Design Response Conference 8/25/2009

Building A Massing & Material Modulation

Notes from 8/31/09 DRB Meeting

**Master Plan and Design Guidelines
Page DG-22 – Gateway District – Site
Planning**

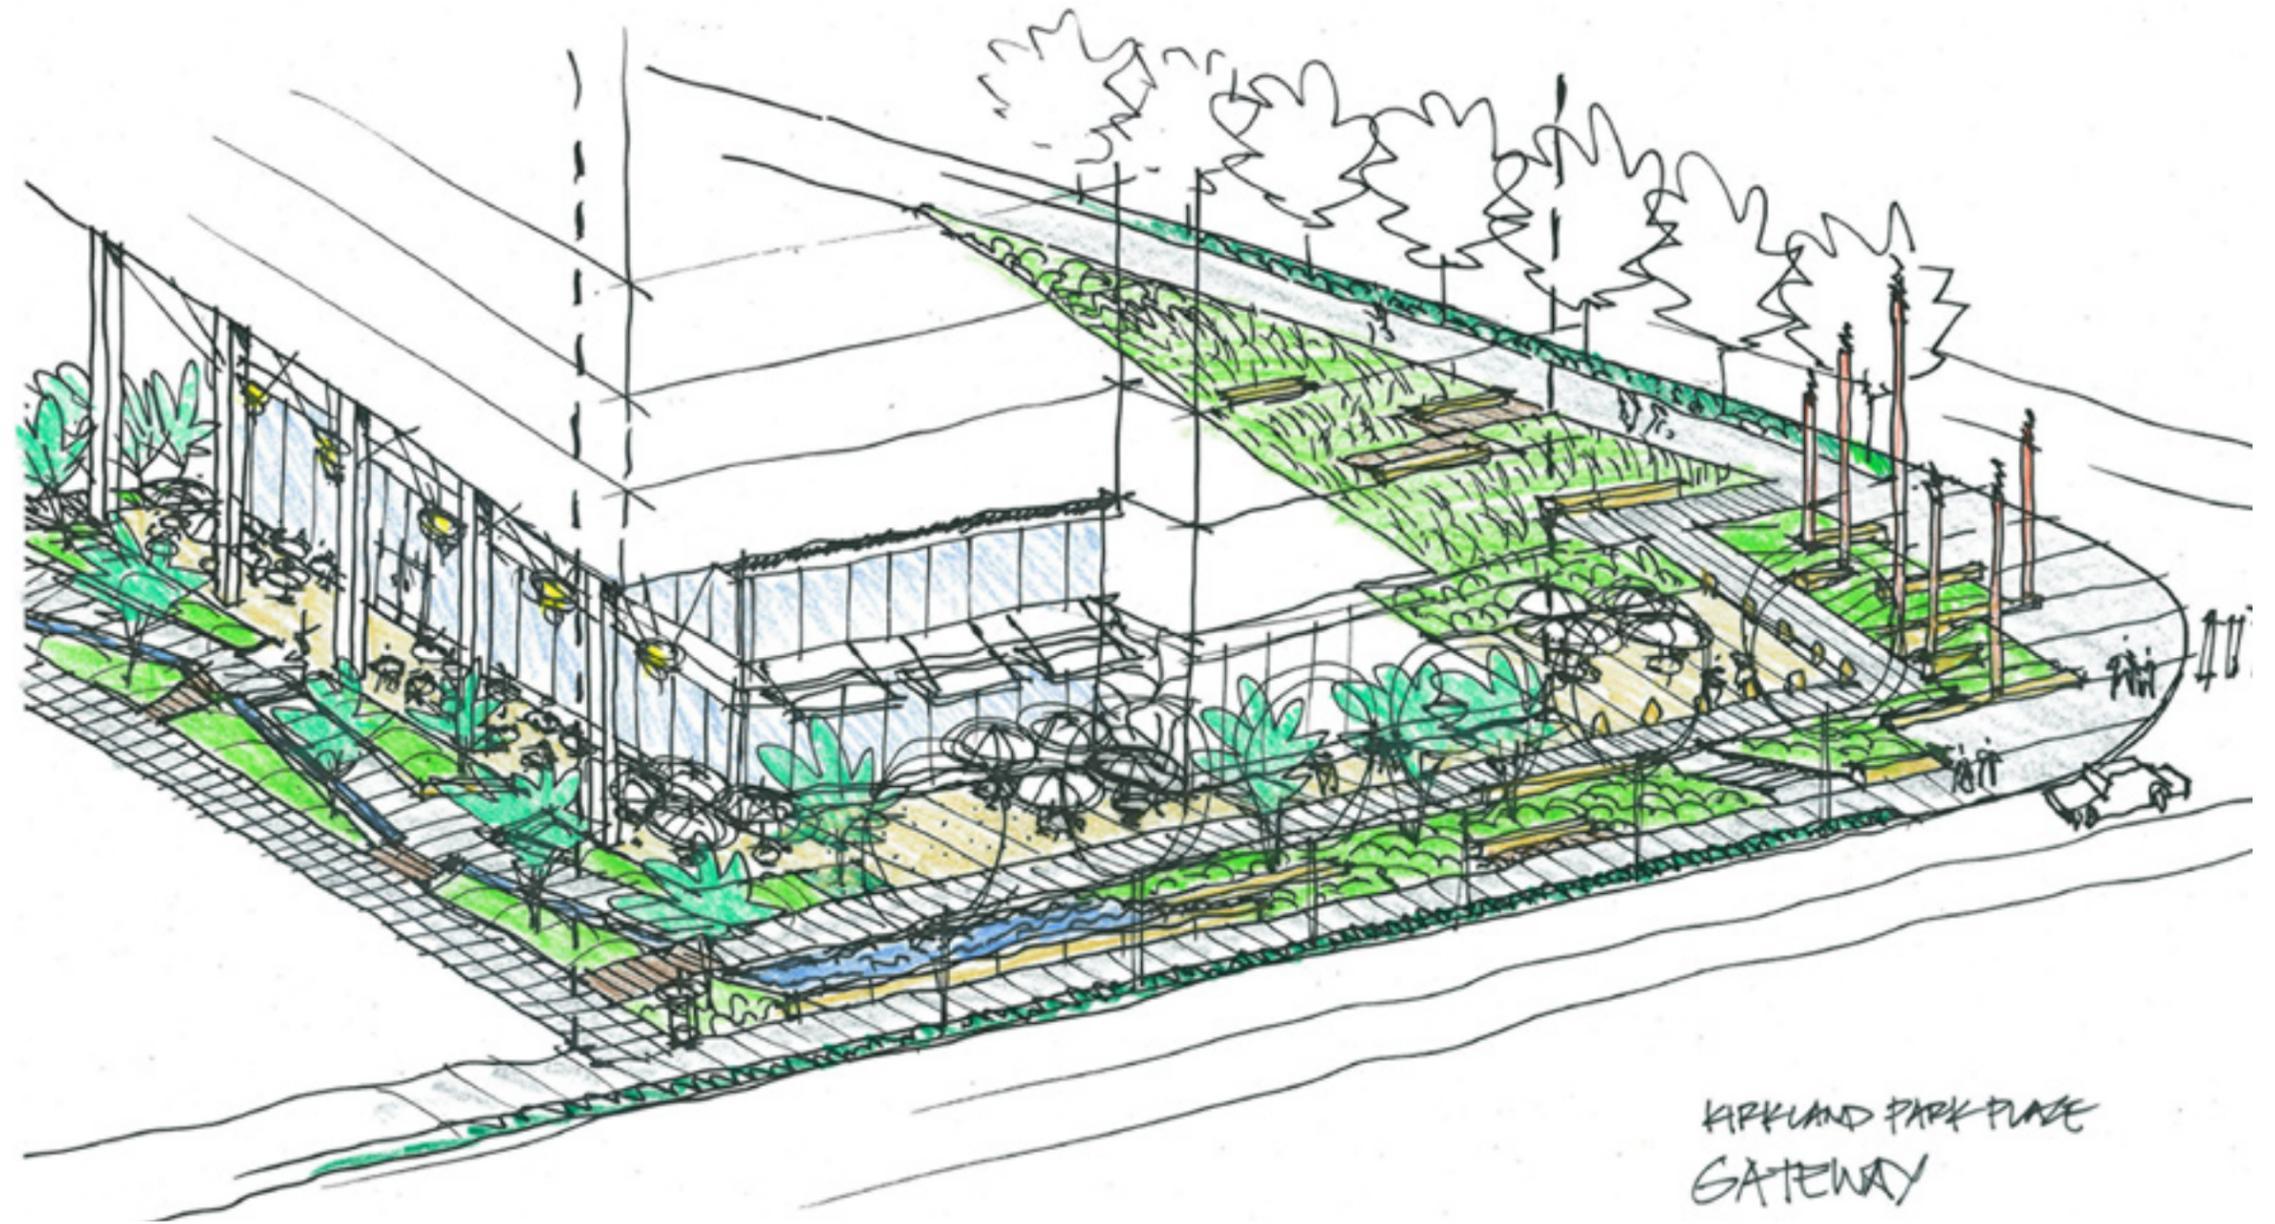
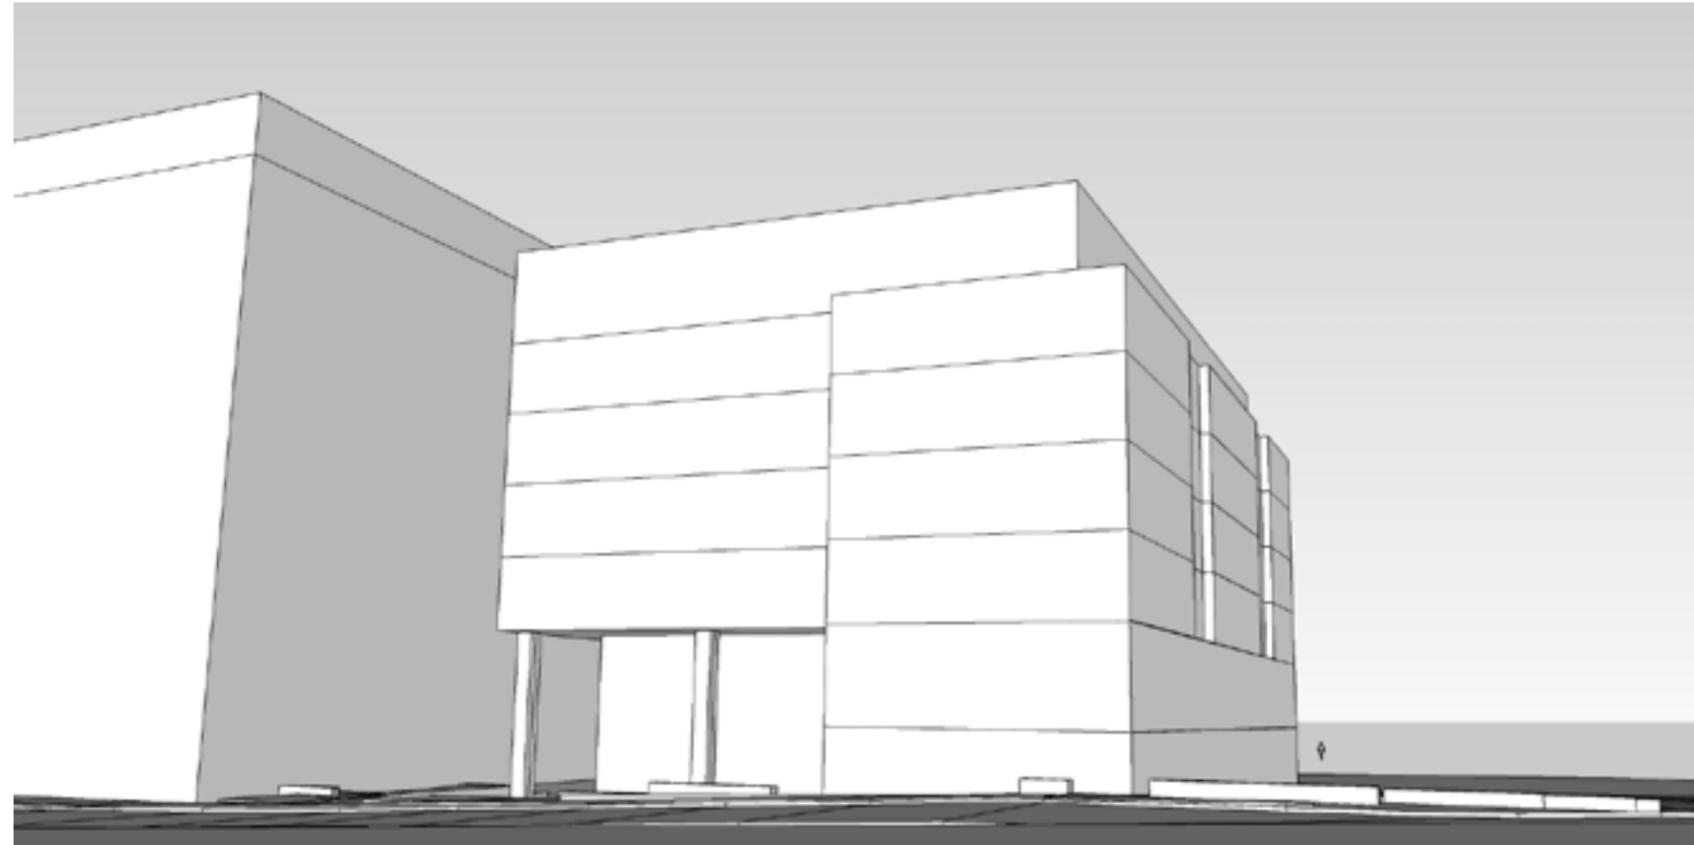
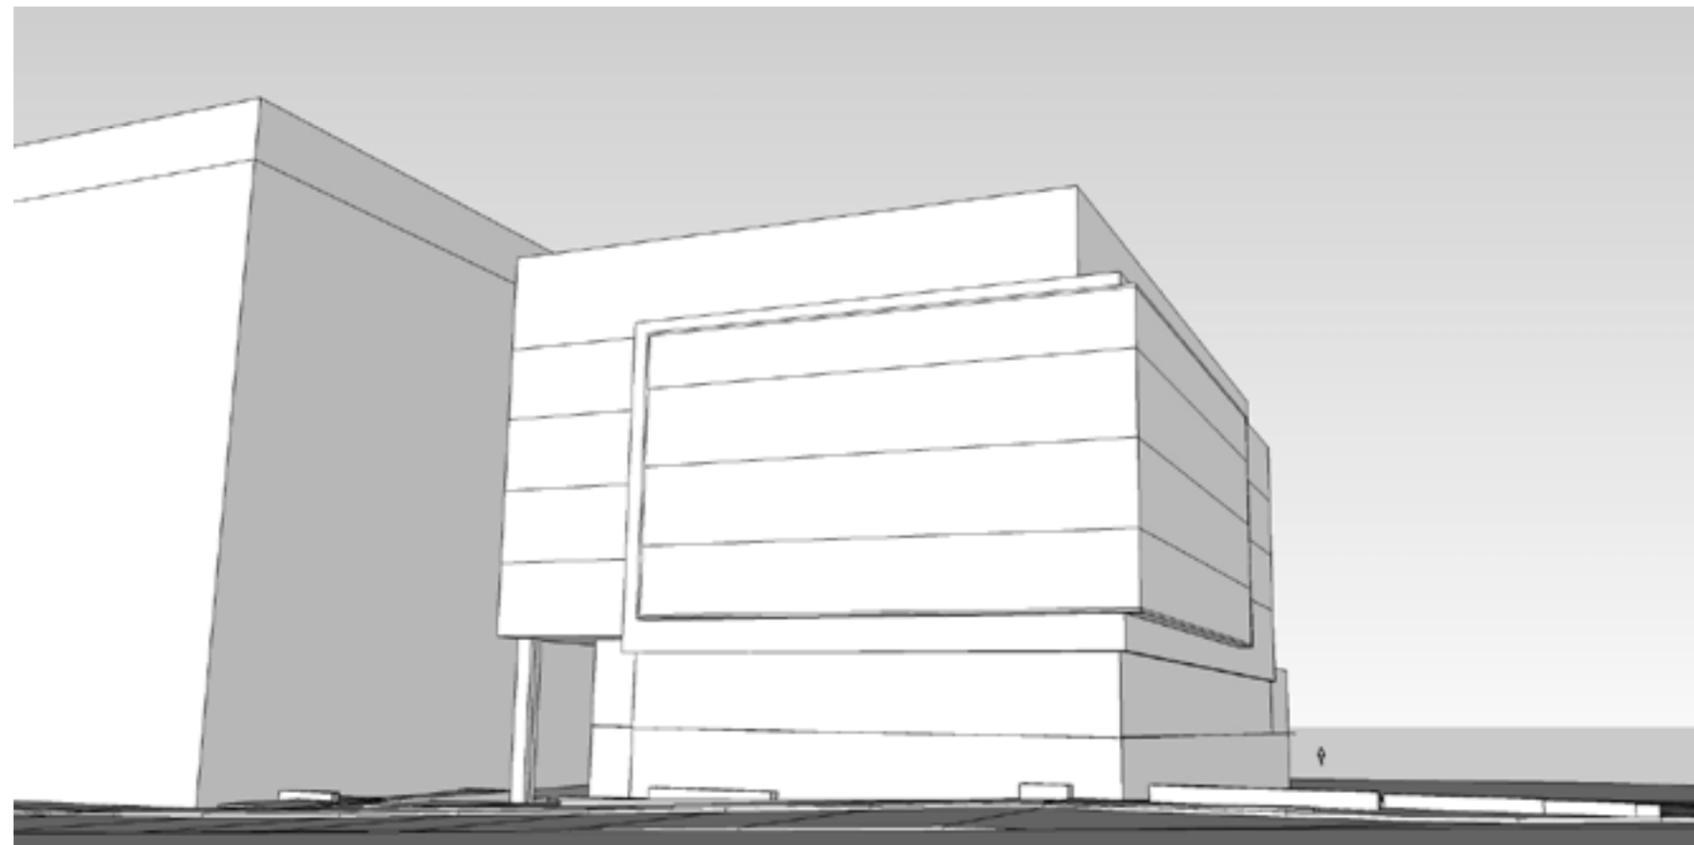
DRB comments: 1. Gateway Garden (a, b, c & d) – Need more design on gateway concept (relationship of plaza to building), need updated drawings and landscape plan for this area. Need more of an "ah ha" moment! Maybe more symbolic rather than an actual entrance... this is still a concern.
2. Triangular Lot public space...see gateway garden comments.

Response: The revised scheme for Building A incorporates a deeper 'cutaway' at the corner, which provides increased views into the Central Plaza. In addition, the massing at the northeast corner has been brought down to the sidewalk to create an urban gesture. The landscape design has been revised to complement these moves.

Master Plan and Design Guidelines
Page DG-24 – Gateway District: Building Design

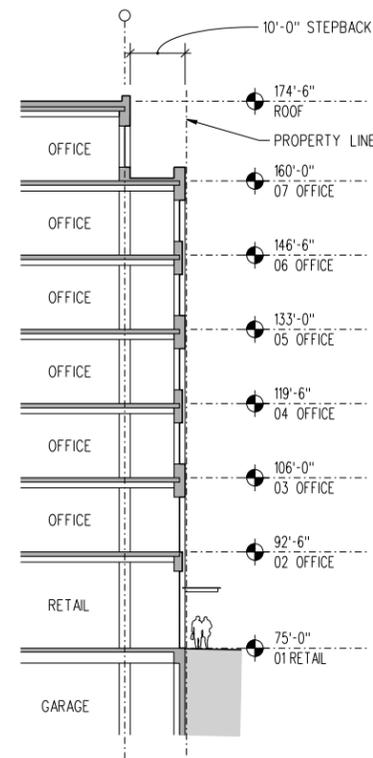
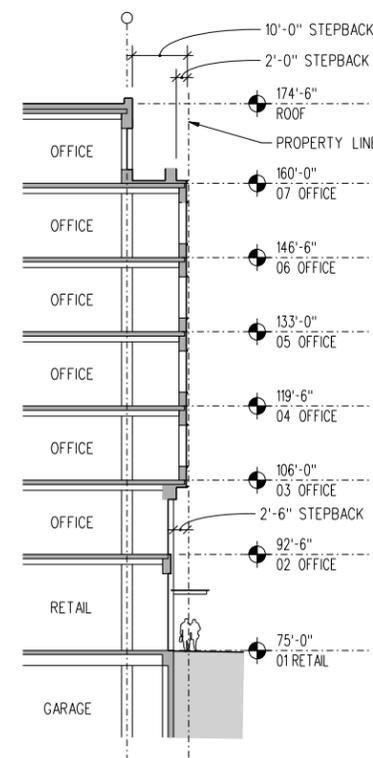
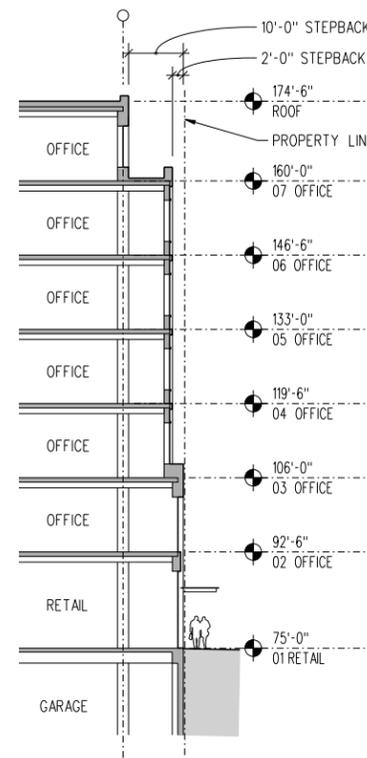
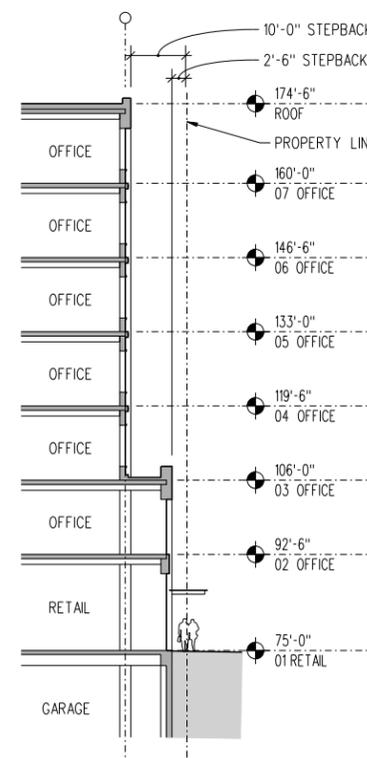
DRB comments:
 1a – Ground level setbacks from street – relates to previous conversation.
 1b – Retail/restaurant uses - concern
 1c – Details visible at different movement speeds – don't have at this time so it's a concern
 2b – Upper levels step backs: a concern remains about whether design meets the intent of this guideline. This shouldn't just happen in one area of the building.

Response: The revised design for Building A incorporates the stepback along the predominant portion of the Central Way elevation. It is interrupted only in order to satisfy the requirement for horizontal modulation.

**Master Plan and Design Guidelines
Page PO-5 – 8. Design Intent**

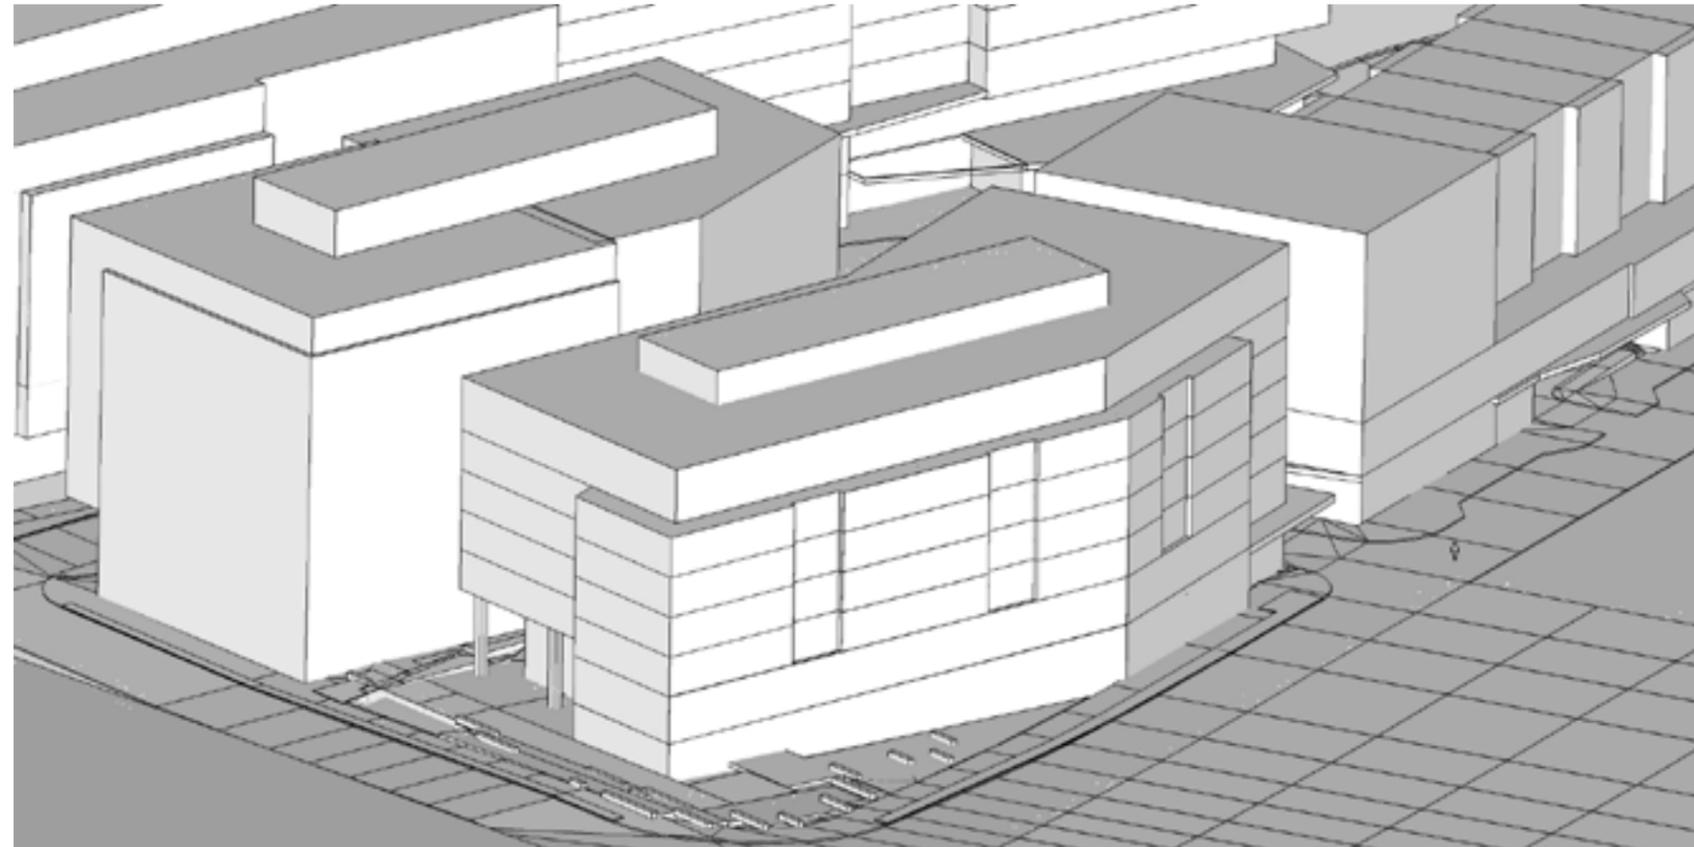
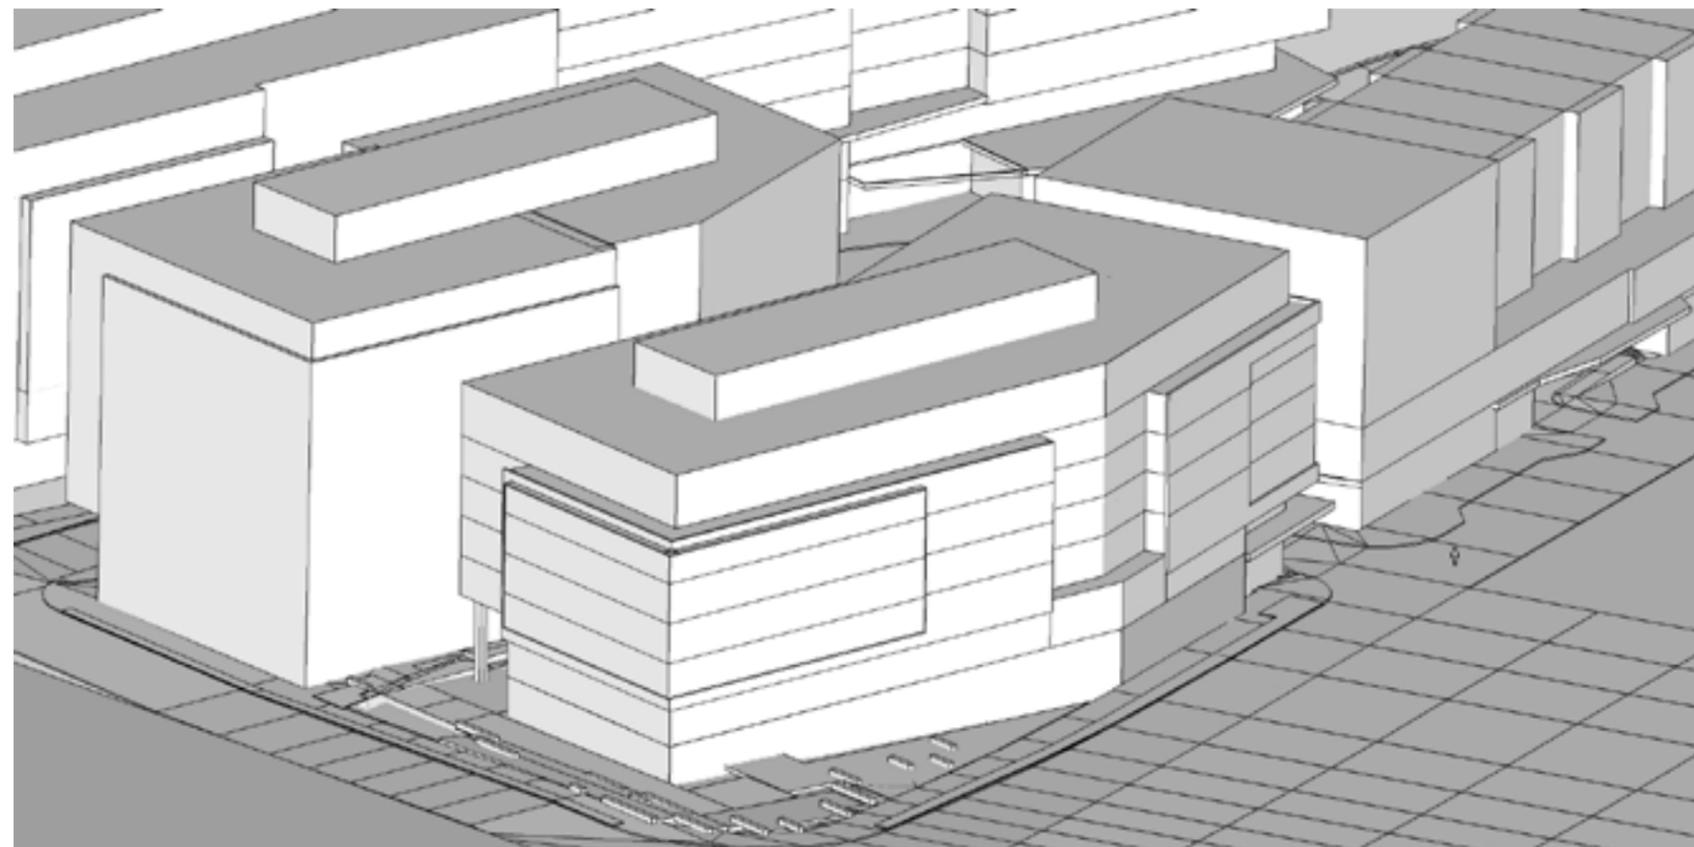
DRB comment: Strong emphasis on streetscape and provide clear and inviting public access.

Response: At the intersection of 6th Street and Central Way, building A sets back 40' from 6th St. to create a public space at the corner. From this corner plaza, the landscape and hardscape design lead the user into the space between buildings A & B. This space is activated by landscaping and water features, as well as the spill-out from adjacent retail and restaurant uses. From within this space, the breezeway is visible, and frames views through the space towards the Central Plaza beyond.
